Environmental Review Team Report

Christy Hill Subdivision

Franklin, Connecticut

Environmental Review Team
Report
on
Christy Hill Subdivision
Franklin, Connecticut
April 1978

PRELIMINARY SUBDIVISION

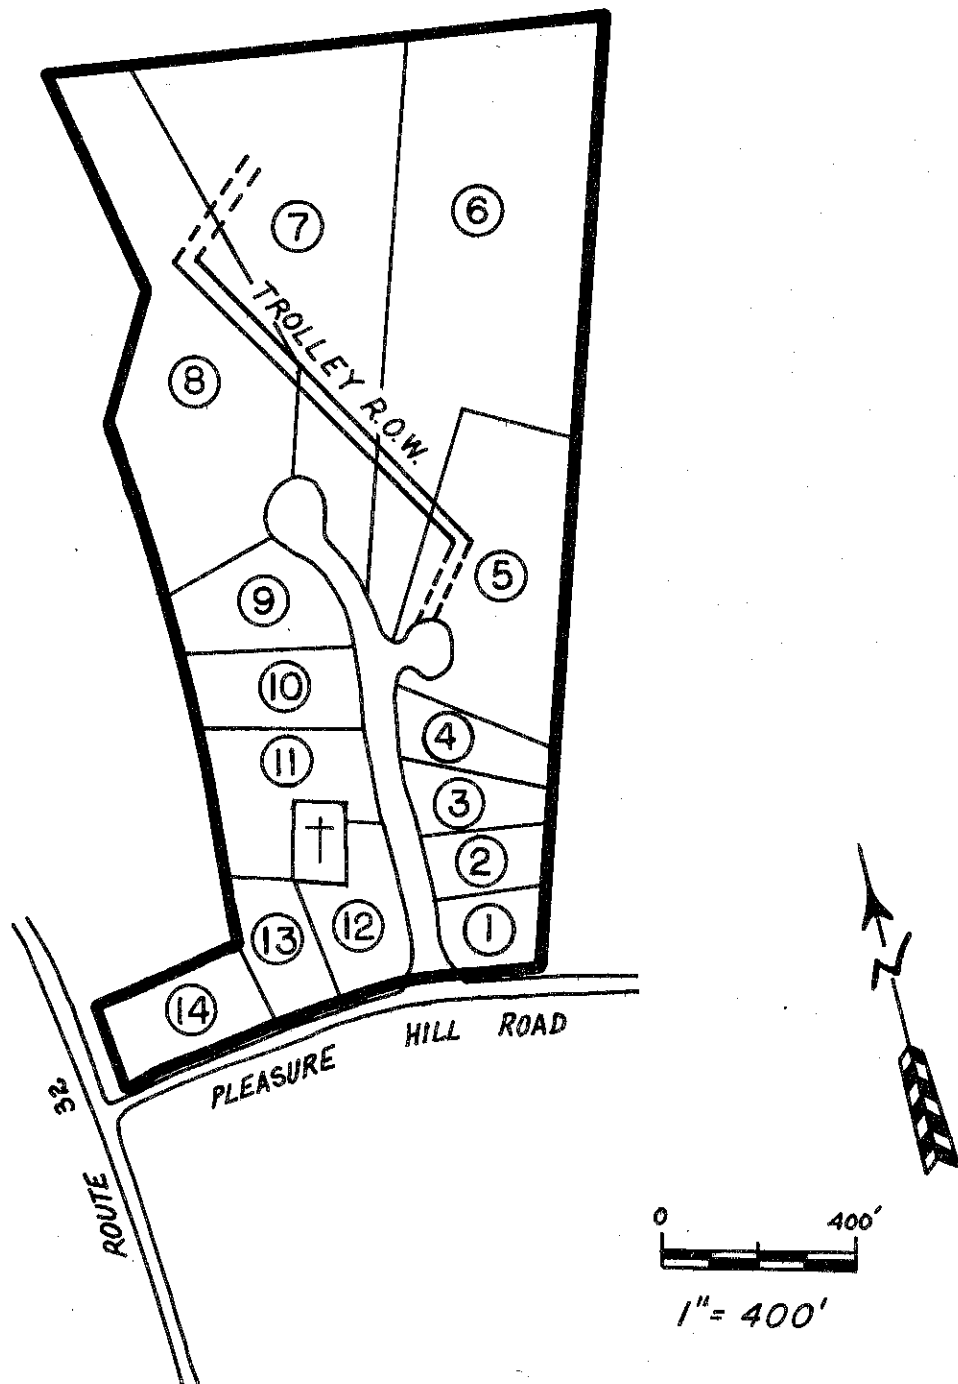
The Team's general concerns on this site are with the steep and erodable soils, the inevitable disturbance to the wetland, road and lot surface drainage and septic system design and placement. After review of the site and preliminary subdivision plan, it is evident that construction on lots 1 through 4 and lots 9 through 13 will not require wetland disturbance or any major earth movement. Construction on lots 5 through 8 will cause a major environmental disturbance and will eventually have a significant impact on the wetland area. We are concerned that drainage from any development on this site is liable to contribute to pollution and sedimentation of this wetland, but it is the Town's charge to weigh the possible environmental disturbance created by the development against the overall benefit that the Town could derive from this subdivision. Briefly, the Team feels that Christy Hill Builders should keep the following concerns in mind when developing the final subdivision plan for this site; erosion control measures should be installed prior to the start of construction, the sequence and maintenance of erosion control practices should be detailed in an erosion and sediment control plan; roads, drainage systems with protected outlets, and utility lines should be installed and roads surfaced prior to house construction, the amount and duration of soil disturbance should be minimized by disturbing only what is needed, when it is needed, followed by immediate revegetating of the disturbed area.

The proposed access road crosses drainage draws at four points; the front of lots 9 and 10, the front of lots 3 and 4, the neck of the eastern cul-de-sac,

and the neck of the northern cul-de-sac. Surface drainage should be controlled at these points by either the storm drain system or culverts. Much of the access road also crosses steep slopes and erosion may become a problem on unprotected road edges. Some catch basins and storm drains are shown, but the Team recommends that curbing and a complete storm drainage system including the cul-de-sac areas be implemented on this site.

The section of the access road located from the easternmost cul-de-sac continuing to the northernmost cul-de-sac, is proposed for a very steep slope adjacent to the wetland. Construction on this slope will require extensive cutting and/or filling. The cuts on these slopes will be difficult to stabilize. Moving the road onto the gentler slope to the west is recommended. If steeper banks are not cut and the road is not moved, a certain amount of wetland will need to be filled to make a level road grade with a stable bank.

The rear portions of lots 3, 4, and 5 drain into a brook which runs along the old trolley bed. The present stability of this stream channel is questionable. Development plans should incorporate any needed channel improvements. An adequate and stable channel design for the post-development peak flows should be established prior to construction activities.

The higher, dry ground provided by Canton-Charlton soils toward the back of lot 5 is suitable for a house. Access to this section of land will require wetland filling and a stream crossing. If a house is built on the front section of lot 5, special consideration should be given to avoiding surface drainage problems and steep slopes. The proposed access road in lot 5 appears to create a drainage pocket. A small culvert may be needed under the drive to alleviate this problem.

The proposed subdivision has access from Pleasure Hill Road. This access will have two cul-de-sacs to provide turn-around and minimum frontage on some lots. The access to lots 5, 6, 7 and 8 is over abandoned farm cart paths and an old trolley bed.

The traffic coming onto Pleasure Hill Road from the development would not have adequate visibility to the west unless the slope is cut back to accommodate this. The visibility to the east is limited to about 200 feet due to a curve in Pleasure Hill Road.

The Town is expected to accept and maintain the paved access road in this development. The indicated catch basins on this road and the fact that the road will be constructed across sloping fields indicate that curbing will be needed. The proposed road has a storm drainage system that outlets into the wetlands at lot 6. This outlet should also provide outlet for the surface water from lots 9, 10, and 11. The pipe outlets should be protected from developing scour holes by riprap or other permanent protection as well as the baled hay erosion check.

As explained above, a host of problems seem to exist with the proposal to use the trolley road bed for access to lots 5 through 8. At the pre-field review meeting, a Town resident familiar with the trolley road noted that it had been flooded several times during its active use many years ago. The road is likely to be flooded more frequently under the proposed plan, making access to the houses difficult. Lots 5 through 8 are called "mini-estates" on the engineer's preliminary plan, but much of the acreage is regulated wetland. The Team recommends that these lots remain undeveloped until such time that access to them can be gained along a better route.

Access to lots 6, 7, and 8 is by means of a common driveway, eight to ten feet in width consisting of the old trolley line and two cart paths which traverse the regulated wetland soils. Section 3.9 of the Franklin Zoning Regulations requires that "no building other than an agricultural building shall be permitted on a lot that does not have frontage on and direct access to a street." A street is defined as an "improved right-of-way accepted for public use by lawful procedure and suitable for vehicular traffic."

Lots 6, 7, and 8 do not have direct access to a street but will require over 1,000 feet of this common driveway. Even with deed restrictions specifying owner responsibility for driveway maintenance the possibility still exists for future citizen requests for the Town to make costly improvements if problems develop with access and movement of snow plows, oil trucks, fire trucks, and emergency vehicles. One of the reasons for the adoption of subdivision and zoning regulations in southeastern Connecticut communities was that unpaved roads with 3 or 4 homes along them were evolving into town roads at town expense. Although the FIA flood hazard map is not available for this area of Franklin, the former trolley bed in some locations is not much higher in elevation than the brook flowing through the site so the possibility of flooding exists.

The portion of lot 5 closest to lot 4 appears to have enough area to meet the zoning requirements while the portion of lot 8 closest to lot 9 appears to almost meet the zoning requirements. If these two lots could be developed at these locations then only two lots would be lost by providing open space.

WATERSHED

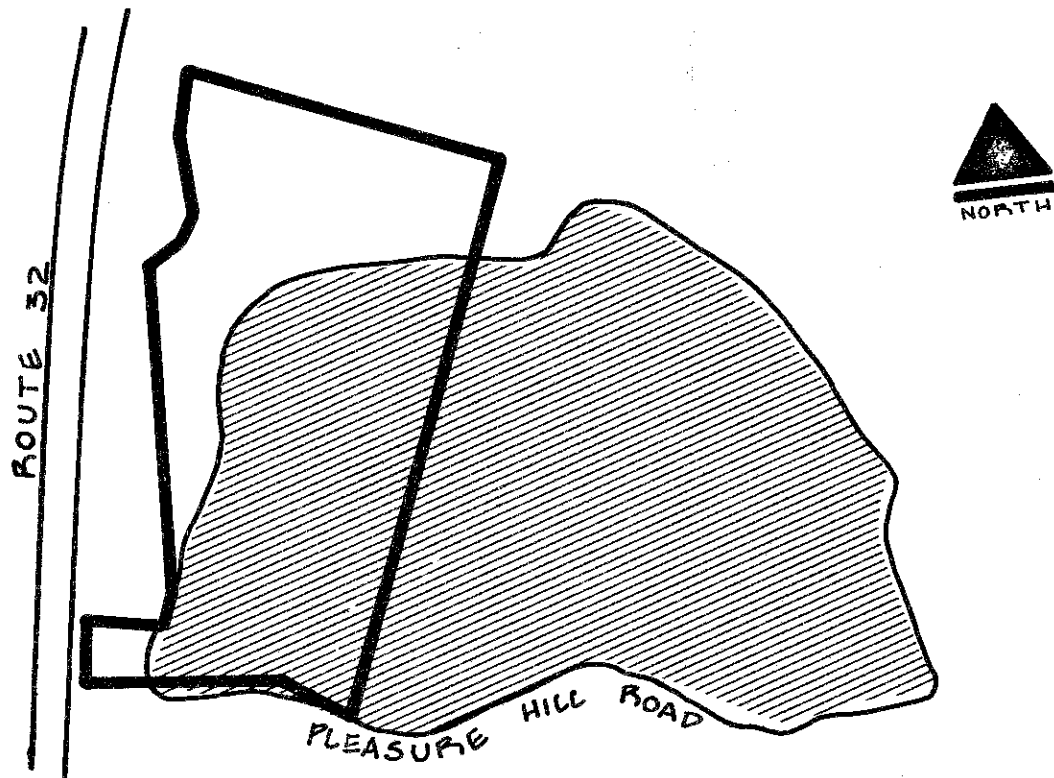
The change of land use from pasture to residential is certain to increase the percentage of runoff for a given rainfall amount. The exact figure for the increase depends upon the extent of the development. Flow in the brook that traverses the property, to the point where it passes under the cart path between lots 7 and 8, originates in a drainage area of approximately 76 acres (fig. 1). Assuming that the homeowners maintain either lawns or the current vegetative cover, and that approximately 1/5 acre of land per house will be covered by impermeable surfaces, such as roofs and driveways, an estimate of the increase can be made. The method used for the estimate is detailed in Technical Release No. 55 of the Soil Conservation Service. The runoff curve number (RCN), which relates rainfall to runoff amounts, is calculated to increase by 1 for the overall drainage area. Assuming a present runoff curve number of 60 for the watershed, a future RCN of 61 is predicted. This seemingly small change could increase peak flow in the brook by as much as 11% during a 24-hour, 10-year rainfall event, and by as much as 8% during a 24-hour, 100-year rainfall event. Hence, the chance for flooding, both of yards and of the trolley road, would be greater than it is now.

Watershed area of the brook
traversing Pleasure Hill Road
property to the point of its
underflow at the cart path
joining lots 7 and 8.

FOREST STANDS

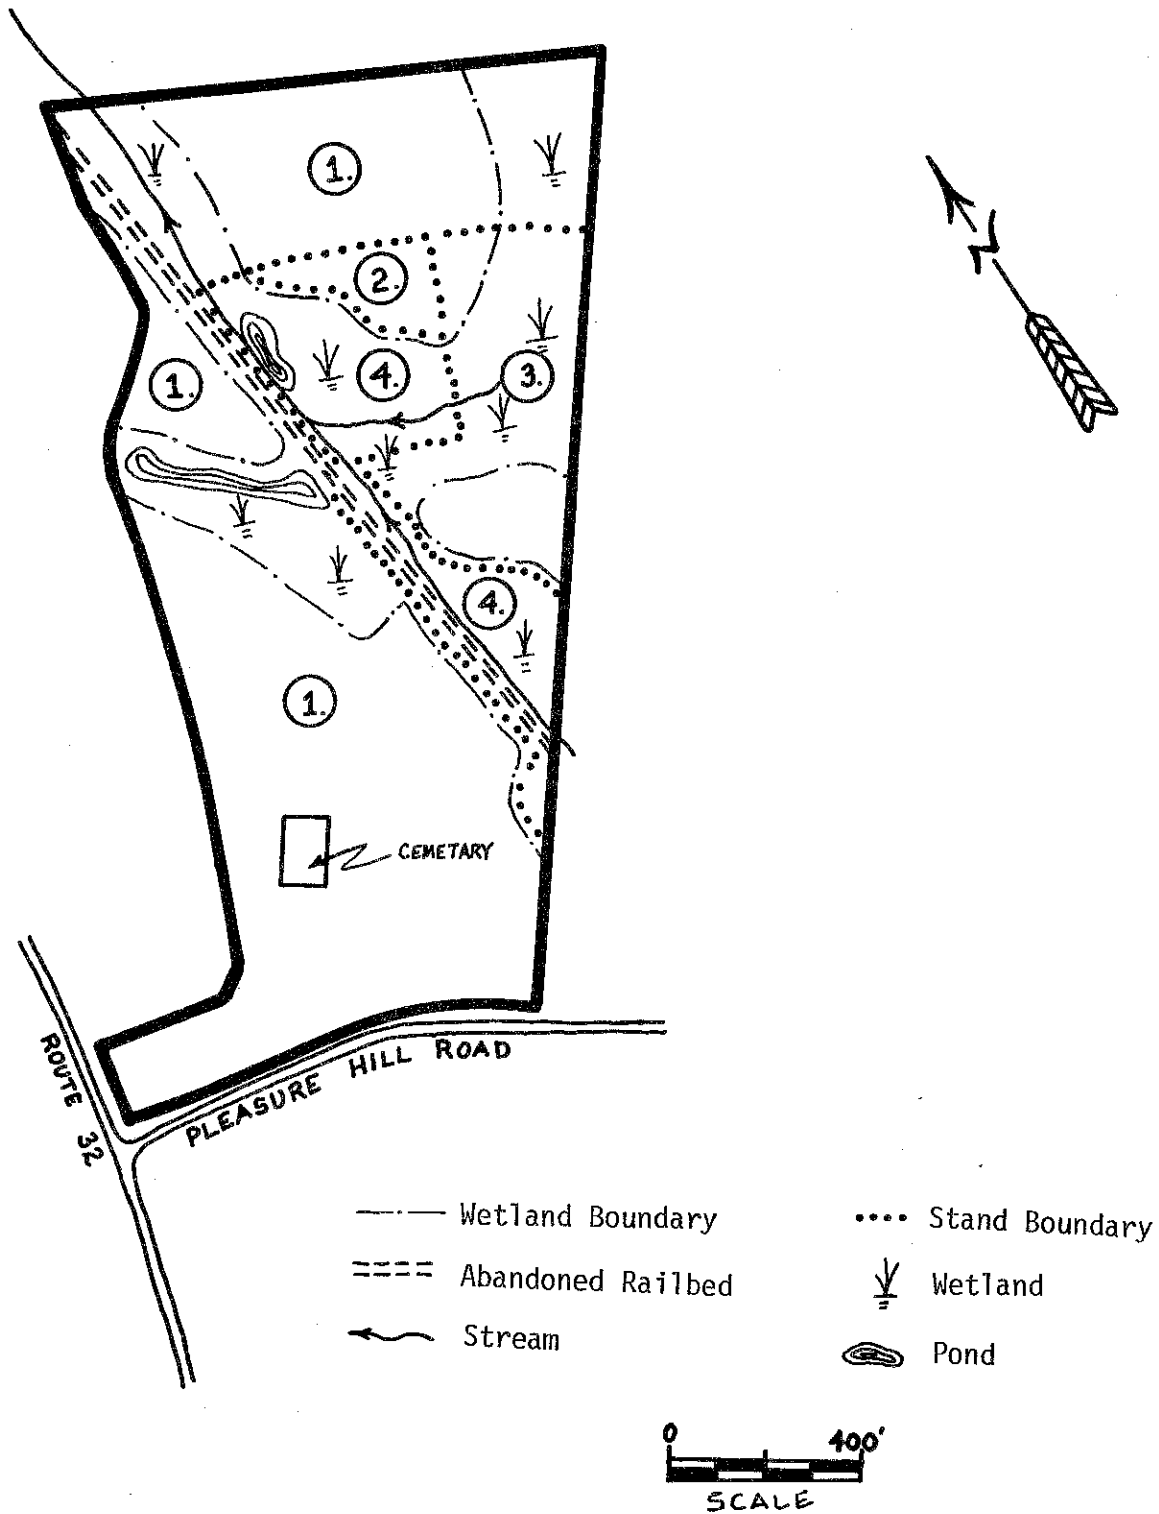
STAND ONE: This area consists of approximately 26 acres of open field. It is populated by occasional red cedar, shrubby growth and large trees near field margins. Development recommendations include planting lot lines and road borders with white pine, larch and hemlock. All large open grown trees should be retained, if at all feasible.

STAND TWO: This area is an old wooded pasture of approximately one acre, dominated by 16 to 20" DBH (diameter of trunk at breast height) red oaks. Due to recent grazing, reproduction in this area is limited to an occasional locust or hawthorne. A cordwood harvest of the poorest quality trees in this area of the site, is recommended to help stimulate vegetative reproduction.

STAND THREE: This old pasture of approximately 5 acres, is dominated by a dense growth of native red cedar and occasional hardwoods. Much of this area has a seasonally high water table. Consideration should be given to retaining this area as a buffer to the wetland and as a wildlife food source.

STAND FOUR: This area is a wetland of approximately five acres, dominated by red maple, black birch, yellow birch and some ash in drier locations. Reproduction could be increased by a cordwood harvest of all trees in poor condition, with a potential yield of 10 cords.
